PRO DEO Lots 9 & 10, Southview Heights

Preliminary Development Plan

Project: Pro Deo Youth Ctr
Issue Date: December 6, 2023

REVISIONS
REV. 1/5/2024

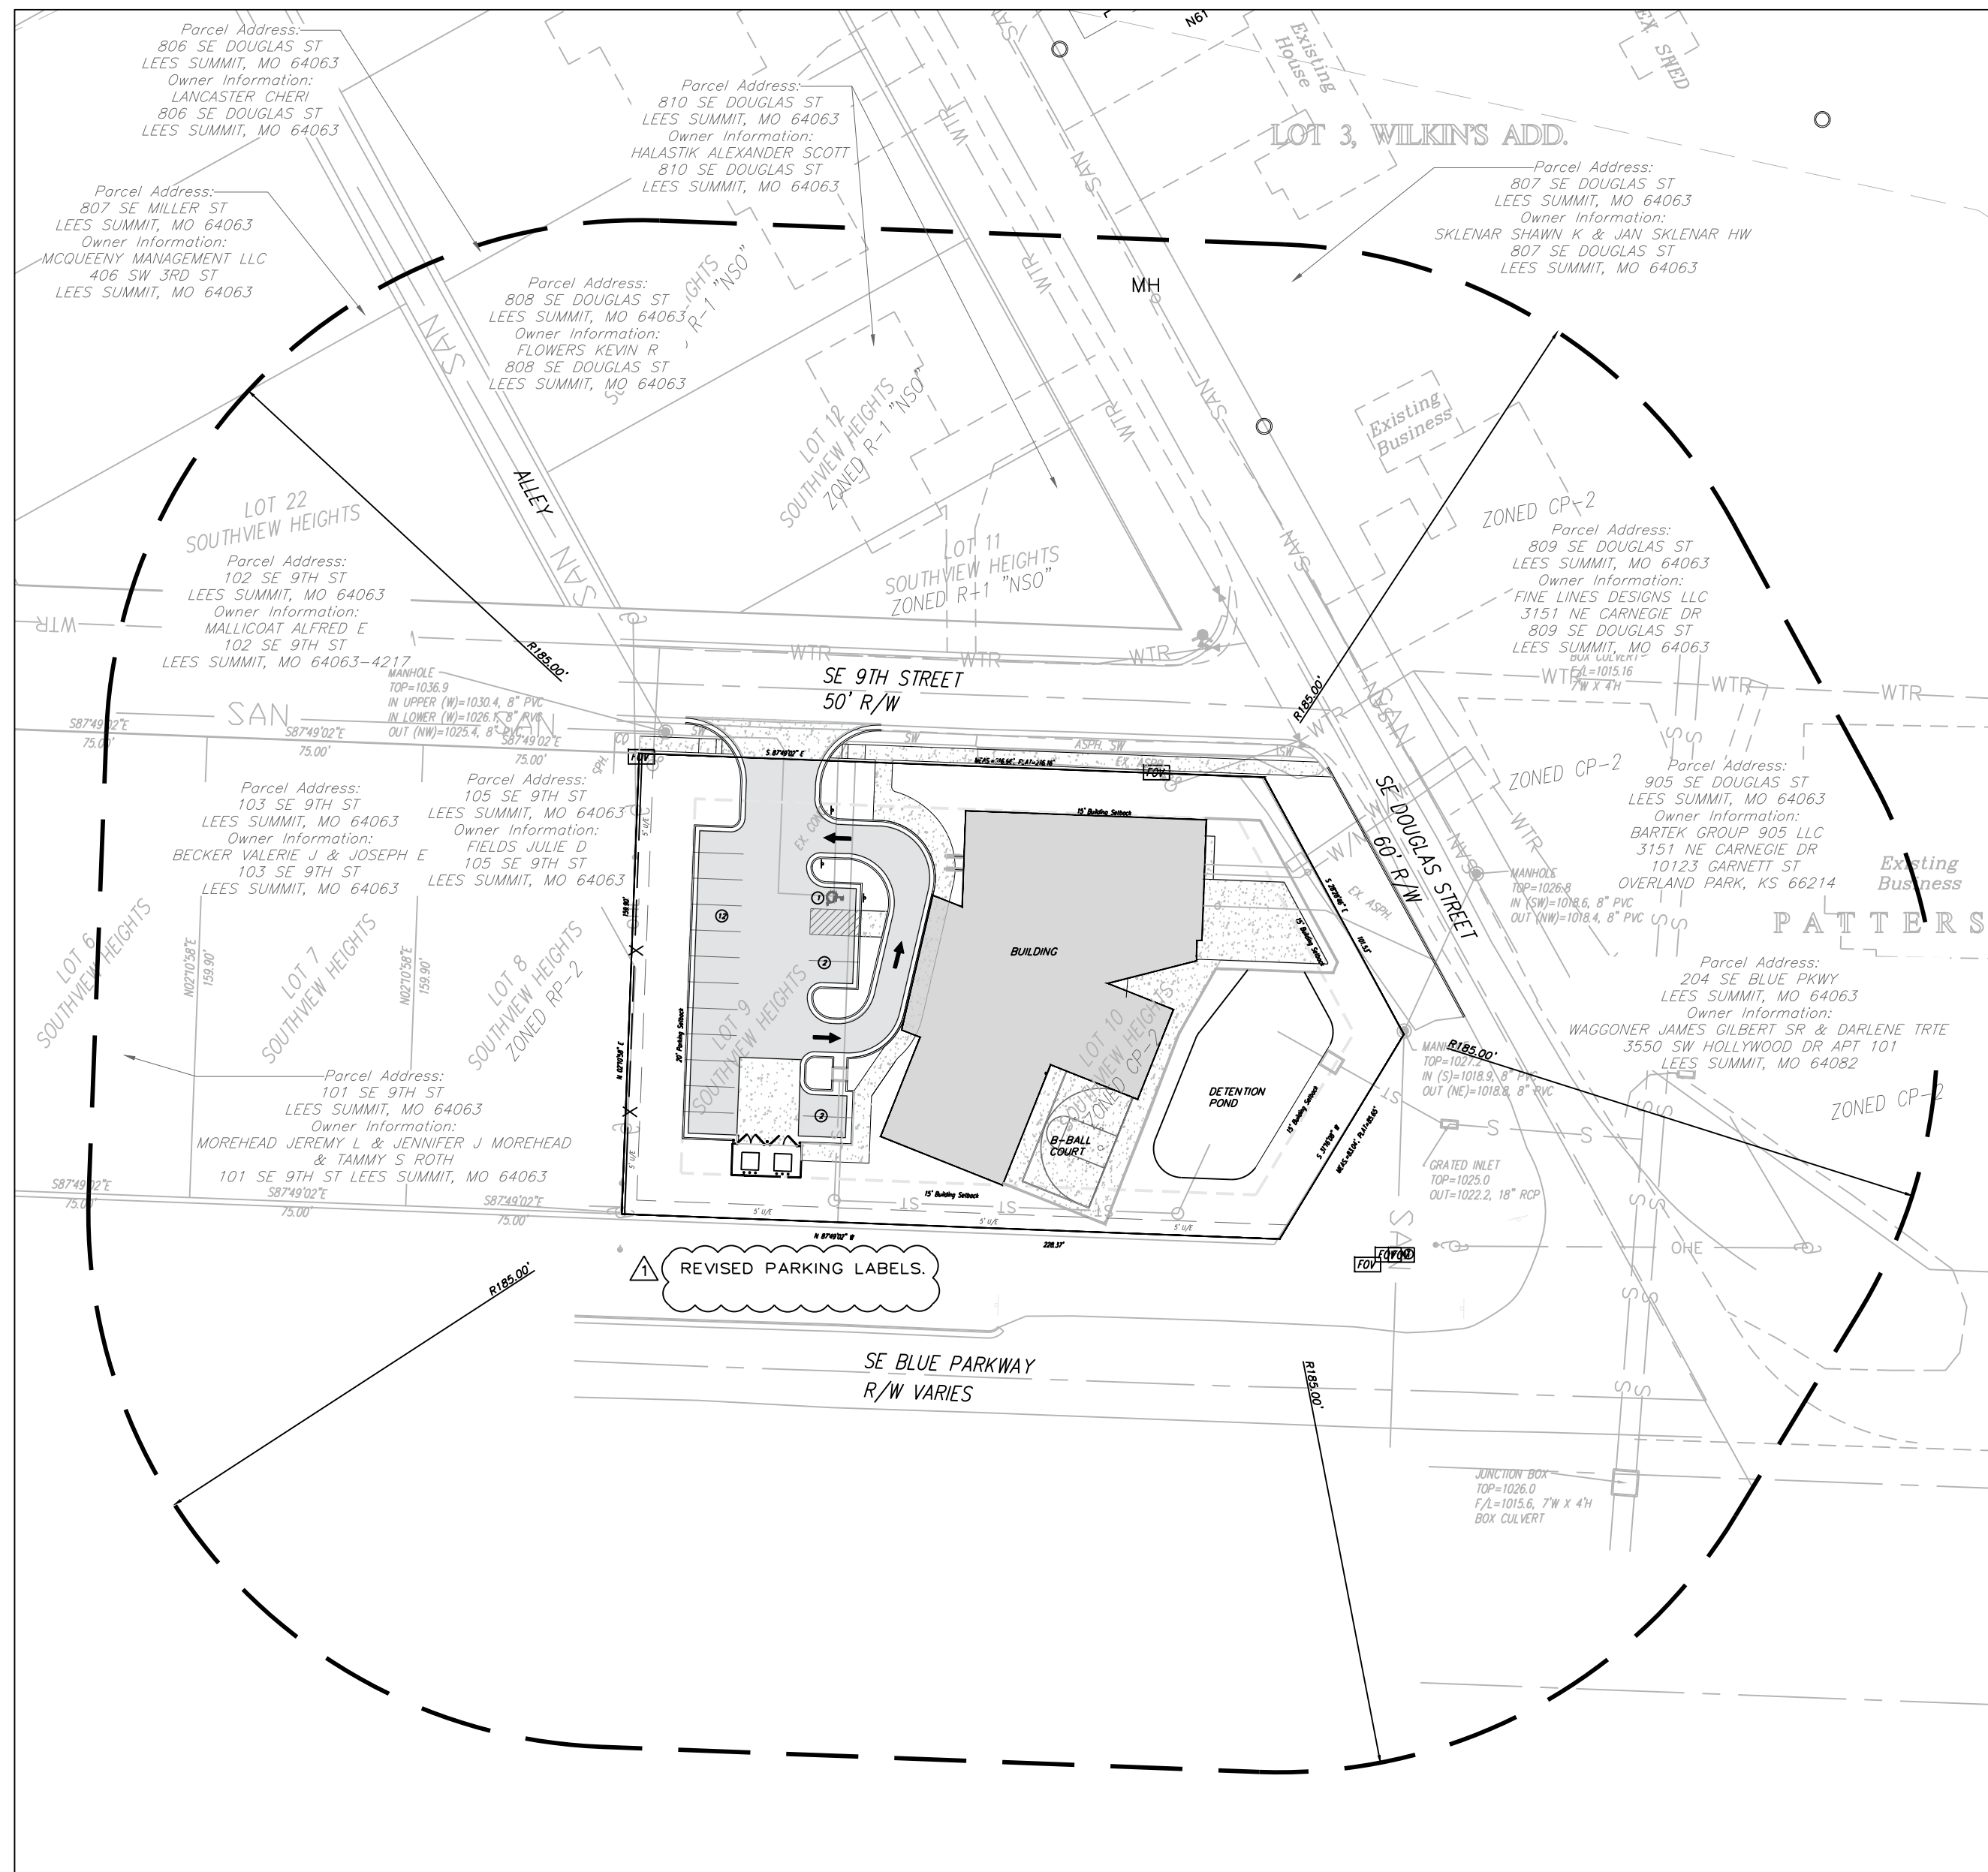
REVISED PARKING TOTAL.

REVISED ZONING.

LANDSCAPE PLAN
Preliminary Plans for:
Lot 9 & 10, Southview Heights
Lee's Summit, Jackson County, Missouri

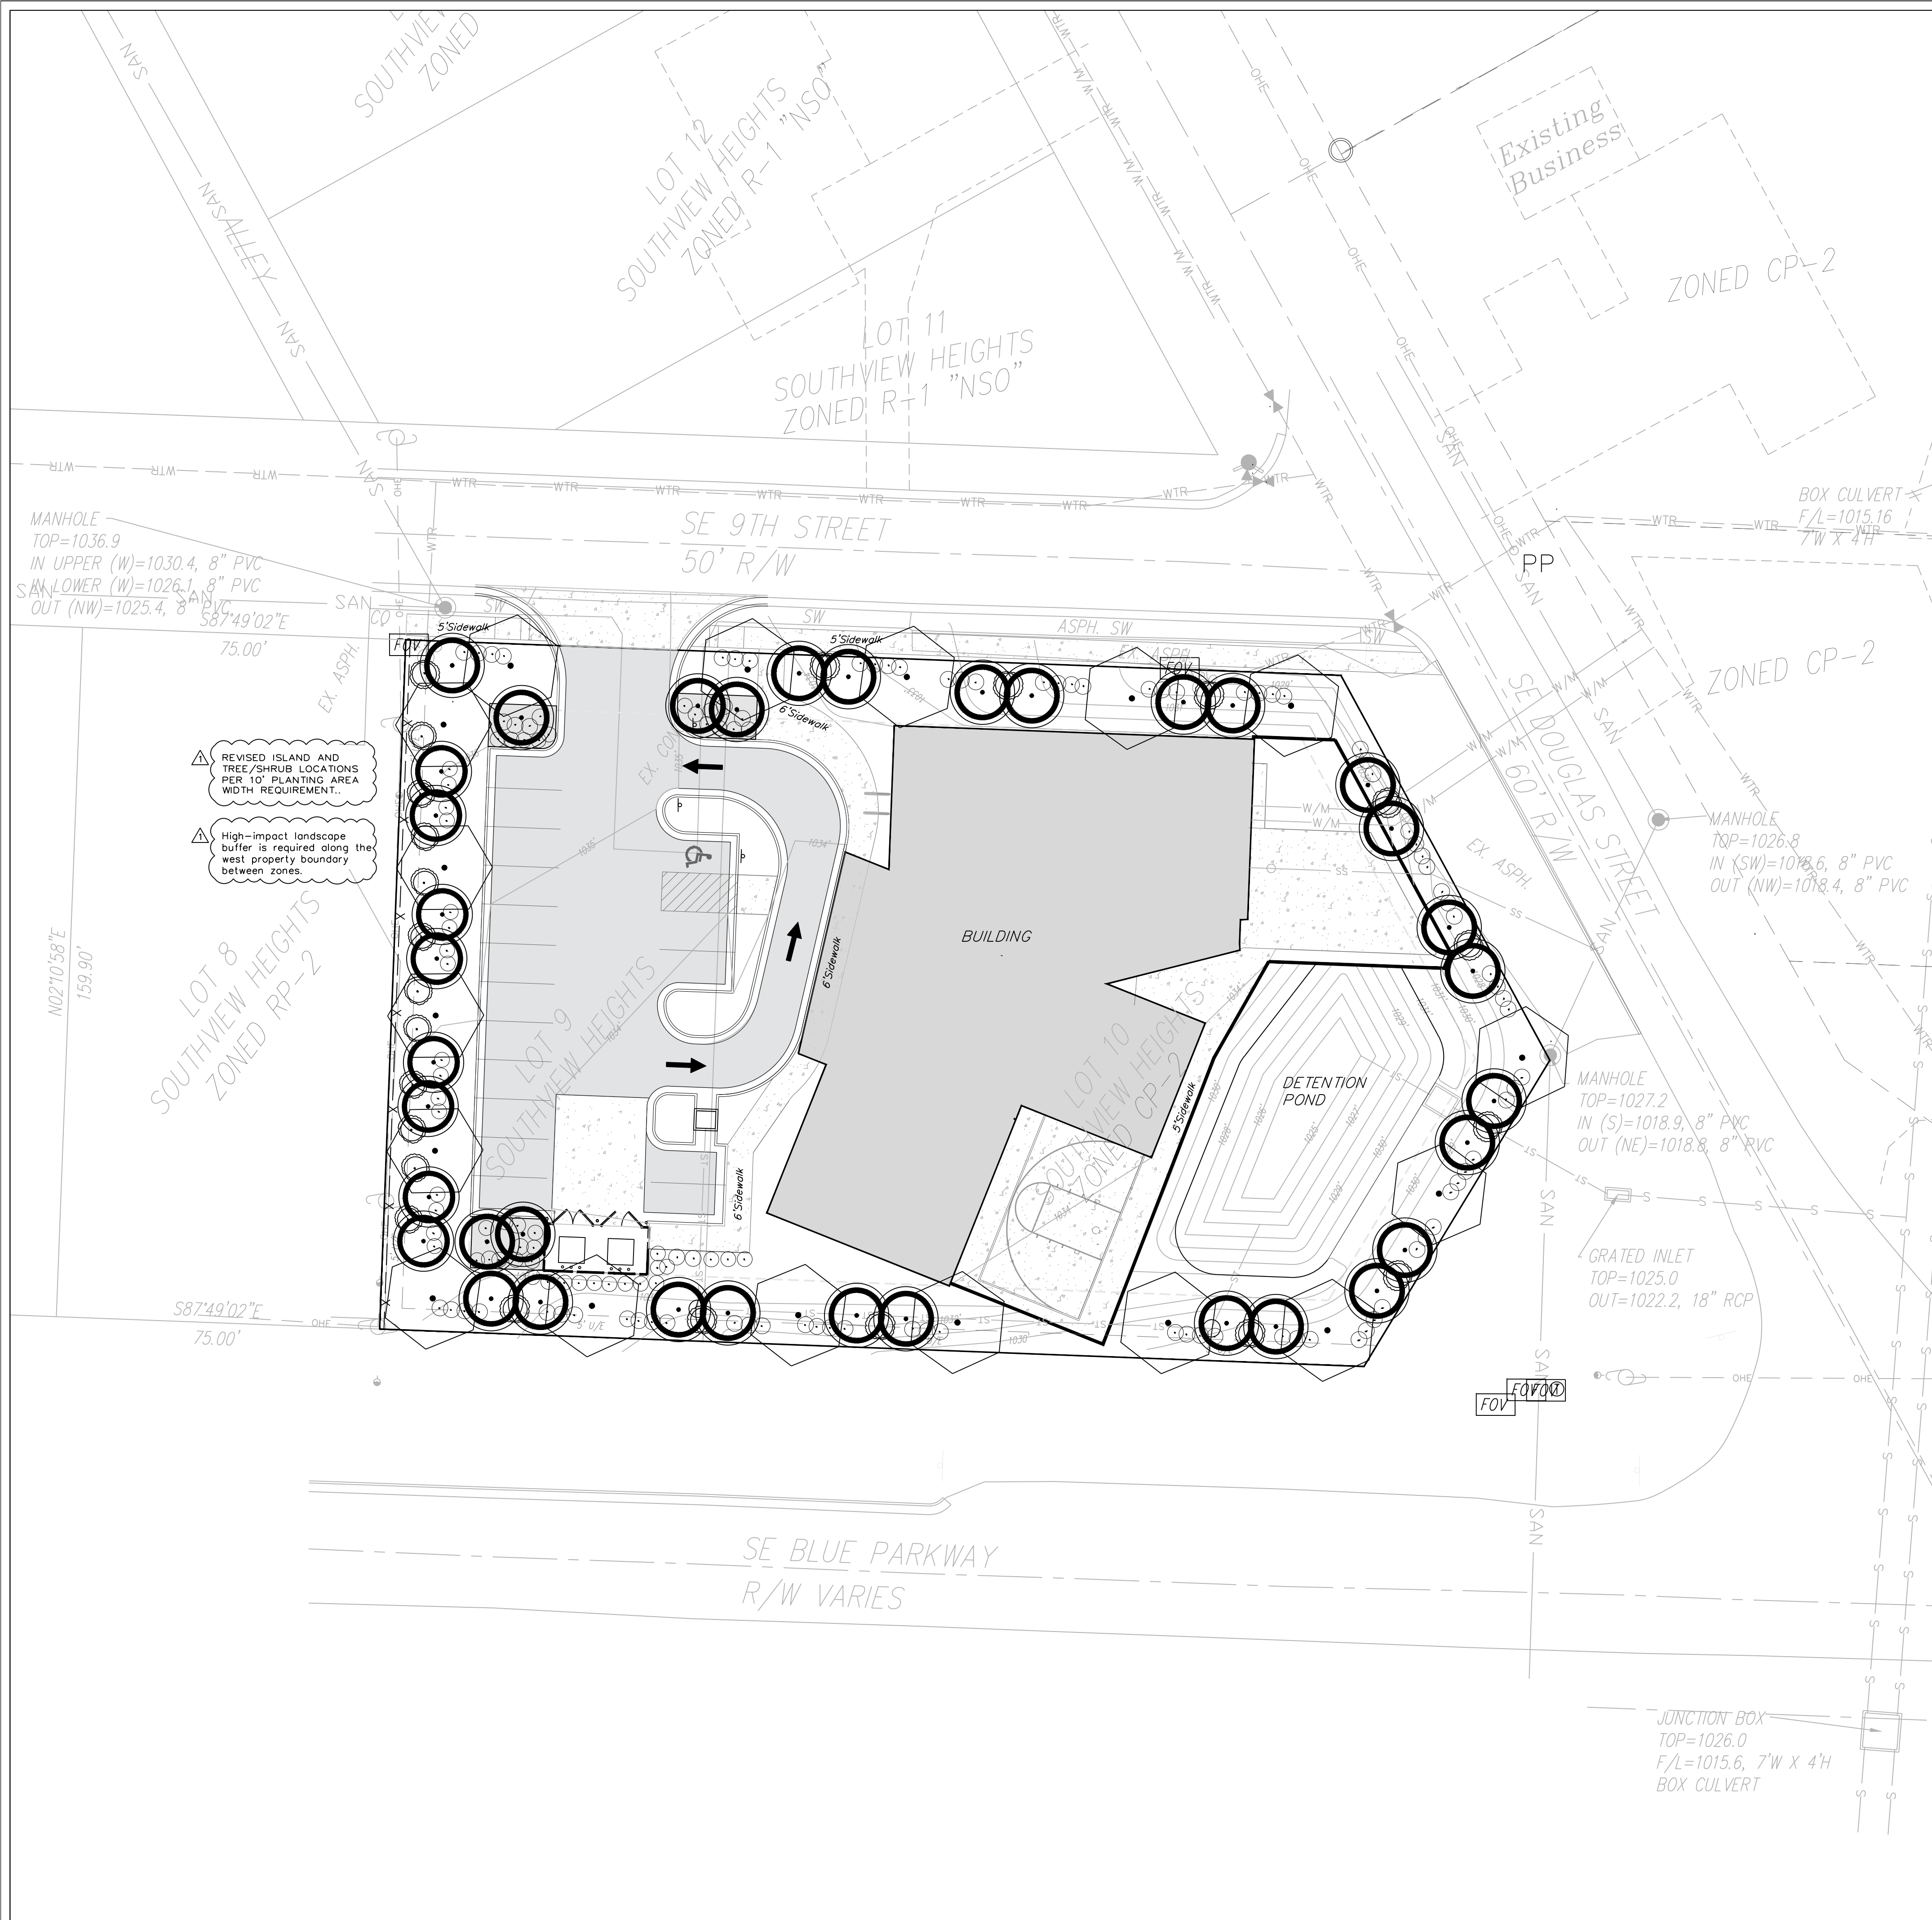
ADDED GROUND MOUNTED EQUIPMENT NOTE.

LANDSCAPE PLAN
SCALE: 1" = 20'
REVISED SCALE.

Note:
All Ground mounted equipment shall be totally screened.
